## **CENTRAL LANCASHIRE LOCAL PLAN EXAMINATION - HEARING STATEMENT**

### **Land at Babylon Lane, Adlington, Chorley (site ref. HS2.5)**

## **RE: RESPONSE TO JBA BAYLON LANE SITE REVIEW DECEMBER 2024**

**Flood Risk Review  
for Planning  
Application  
21/00270/FULMAJ  
and Appeal Refusal  
APP/D2320/W/23/332  
9702: Babylon Lane  
Final Report**

Figure 2-1 amended site boundary and 1% AEP plus 40% climate change flood extent (taken from Central Lancashire Level 1 SFRA, 2024)

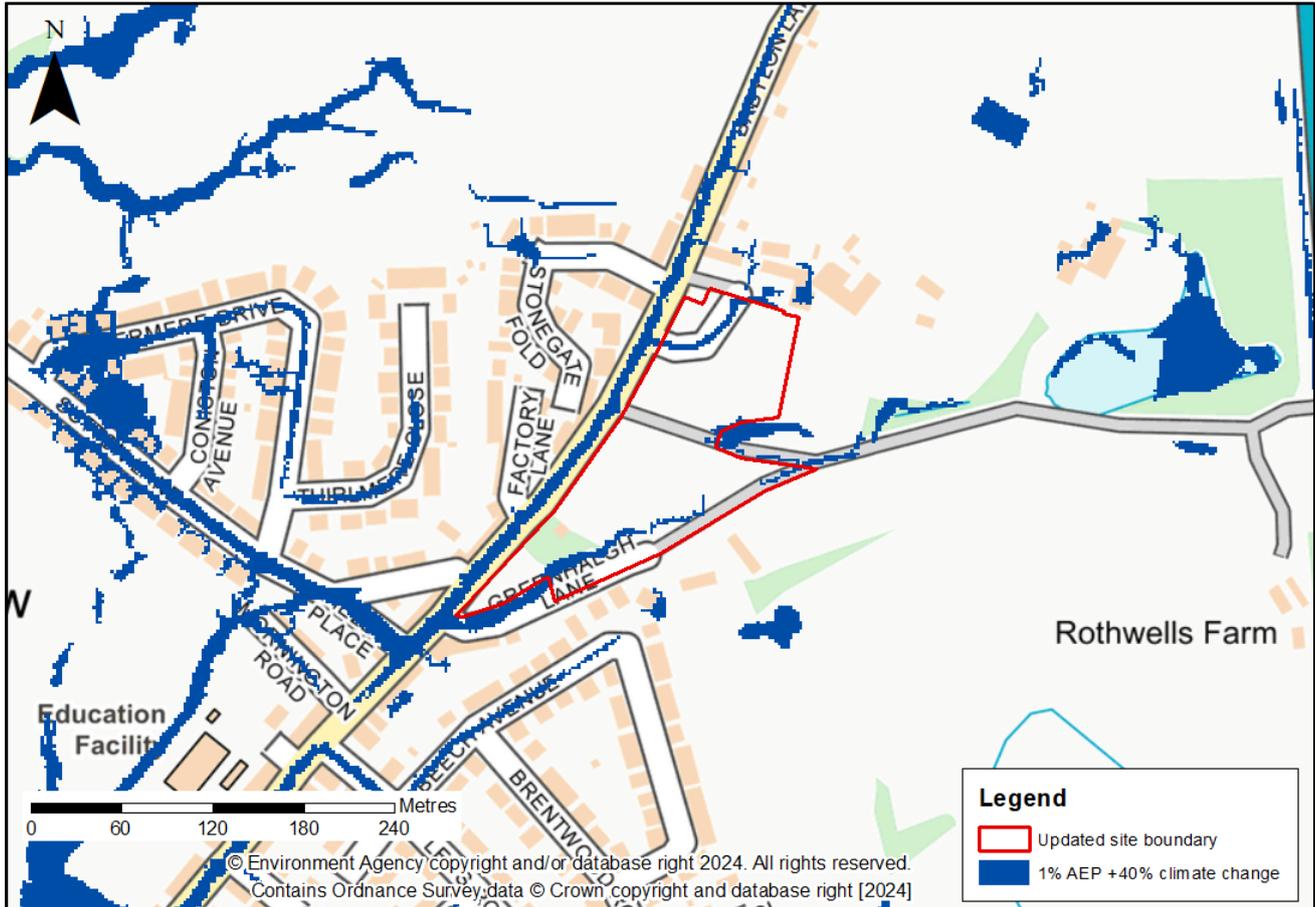
However, the Flood Risk and Coastal Change Planning Practice Guidance (PPG) paras 023 and 024 are clear in that the sequential approach to development should avoid "development in current and future medium and high flood risk areas considering all sources of flooding including areas at risk of surface water flooding". There is no evidence that Gondolin has considered the effects of climate change on surface water flood risk when redefining the site boundary. This would therefore suggest that the site should be subject to the sequential test as it has not considered future flood risk.

Strategic Flood Risk Assessment (SFRA) for Central Lancashire, it is clear that the site is at future risk from surface water flooding, as shown in Figure 2-1.

The boundary revision has not considered the impacts of climate change on surface water, which is a requirement of the sequential test. See Figure 2-1.

As per our previous letter, the updated surface water flood mapping with appropriate climate change allowance was made available to Gondolin and overlaid with the site plan (appended to this letter).

It is acknowledged that national-scale datasets such as RoFSW are accompanied by standard caveats regarding their resolution and suitability for property-level assessments. However, within the context of land-use planning, this mapping remains an appropriate and widely used tool for informing development layout and for applying the Sequential Test at a strategic scale. In this instance, the dataset has been used to guide the siting of development away from any areas of identified surface water risk — consistent with the policy objective of avoiding flood risk through site design.

On this basis, no built development, including access or escape routes, land raising, or other vulnerable elements, is located within an area of mapped flood risk from any source. As such, the proposed development is fully in accordance with Paragraph 175 of the NPPF, which states:

DRAWING TITLE:  
**PROPOSED DRAINAGE LAYOUT**

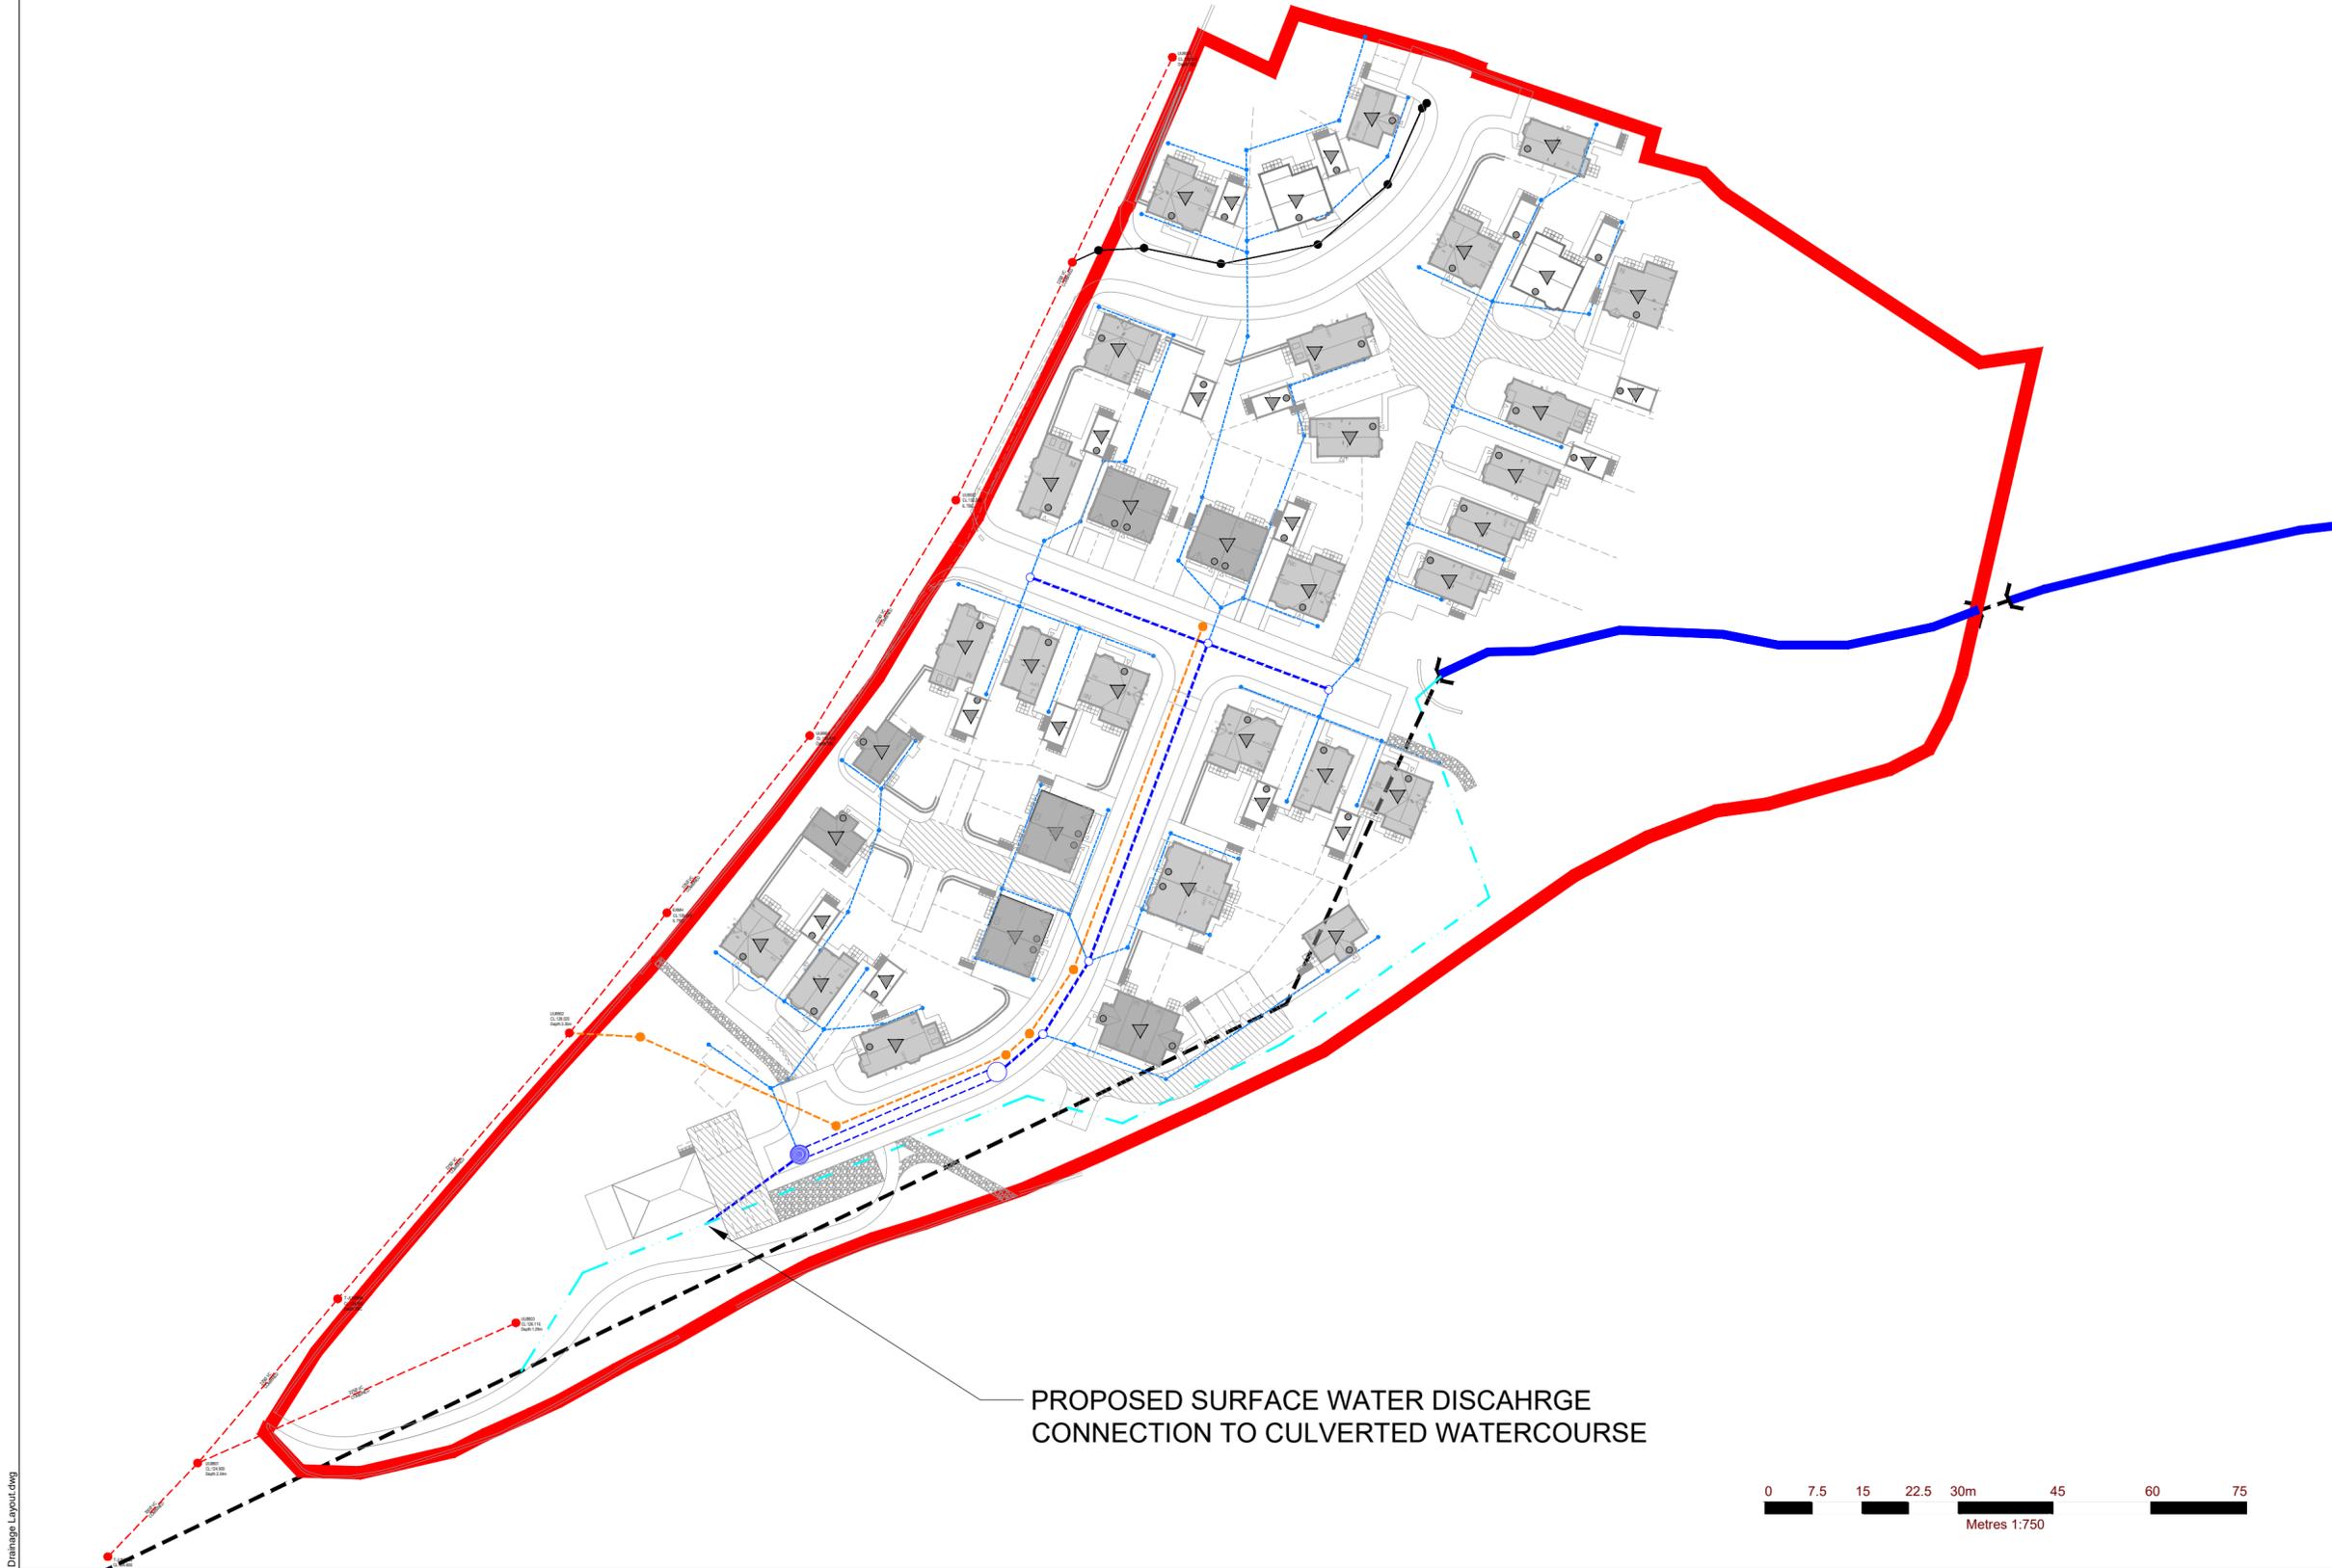
*“Drainage conditions upstream and downstream of the site should be considered in the SuDS design. The wider surface water catchment should be considered in SuDS design and not the site only. The LLFA must confirm the whole catchment area has been considered and surface water modelling has been carried out appropriately to the scale of the development.”*

In our view, a wider catchment-scale surface water assessment is not necessary in this instance. The upstream areas to the north of the site primarily drain either into the highway drainage network along Babylon Lane or towards the lake / lake outfall to the northeast. Surface water flood mapping indicates that any flooding in these upstream areas predominantly follows Babylon Lane rather than flowing through the development site itself. As such, these areas are considered to be hydraulically separate from the proposed SuDS infrastructure, which has been designed to manage runoff from within the development boundary only.

With regard to downstream conditions, surface water runoff from the site will be captured and attenuated via the SuDS network before discharging at greenfield runoff rates to the culvert (BLA-AJP-XX-00-DR-C-0900-P4 - Preliminary Drainage Strategy). The culvert ultimately conveys flows to an open watercourse within the village. Given that the discharge from the development

*“No development (excluding site clearance and enabling works) shall take place until a detailed surface water drainage scheme for the site, based on the principles set out in the approved Preliminary Drainage Strategy (Drawing No. BLA-AJP-XX-00-DR-C-0900-P4), has been submitted to and approved in writing by the Local Planning Authority in consultation with the Lead Local Flood Authority. The drainage scheme shall include:*
